SIL 22-WT-20, Rev. A  
August 04, 2021  
Page 1 of 4

SUBJECT: 3000 Series™ and 4000 Series™ Torque Converter Damper and Turbine Changes

MODELS AFFECTED: 3000 Series™, 4000 Series™, B 300, B 400, B 500, T 200, T 300, T 400, T 500 Models

**Figure 1. Current 3000 Series™ (Left), Current 4000 Series™ (Right)**

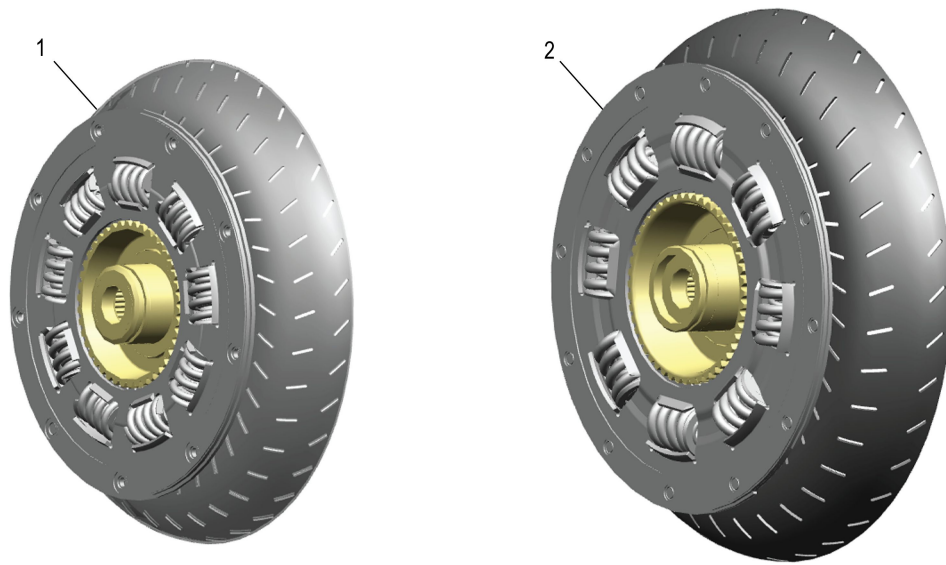
Former part numbers will be completely cancelled and unavailable as service parts when service stock is exhausted. These changes dictate that when installing either of the current damper or turbine assemblies into a former torque converter, both the damper and turbine assemblies must be replaced simultaneously. Doing so will functionally convert the former version torque converter to the current version. Proper matching of components is ensured by a change to the spline count for the mating damper and turbine assembly.

**NOTE:** The 3000 Series™ damper and turbine hub have changed from 40 splines to 42 splines. The 4000 Series™ damper and turbine hub have/will change from 46 splines to 48 splines. Refer to [Figure 1](#).
